World Forum for Harmonization of Vehicle Regulations**Working Party on General Safety Provisions****128th session**

**Awareness of the Proximity of Vulnerable Road Users:
UN Regulation No. 158 (Reversing Motion)****Proposal for Supplement 3 to the Original Version of UN
Regulation No. 158 (Reversing Motion)****Submitted by the expert from the Republic of Korea***

The text reproduced below was submitted by the representative from the Republic of Korea to amend UN Regulation No. 158. The proposal aims to clarify the test conditions of rear-view camera and detection system. This document is based on the informal document GRSG-127-13 which was presented at the 127th GRSG session in April 2024. The modifications to the current text of UN Regulation No. 158 are displayed in bold for new or strikethrough for deleted characters.

Figure 1

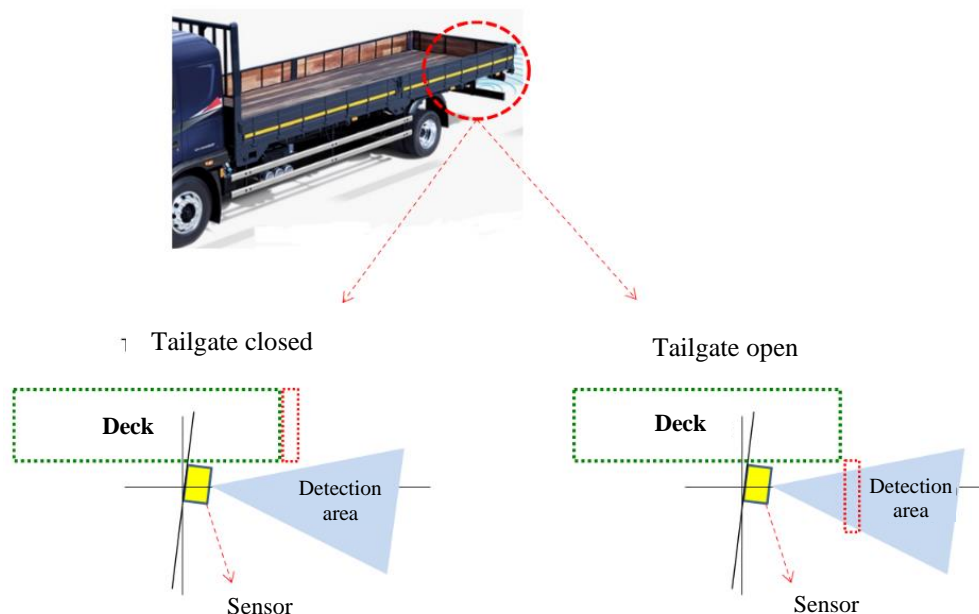
2. In addition, the test conditions should specify that not only rear hatches or trunk lids but also the tail gates of cargo trucks and van-type vehicles should be closed or latched in the normal conditions of vehicle operation during the test. For additional information on this matter, please refer to the following figures.

"1.3.3.4. Rear hatch ~~and~~, trunk lids: **and tail gates**.

If the vehicle is equipped with rear hatches, ~~or~~ trunk lids, **or tail gates**, they are closed and latched in their normal vehicle operating condition."
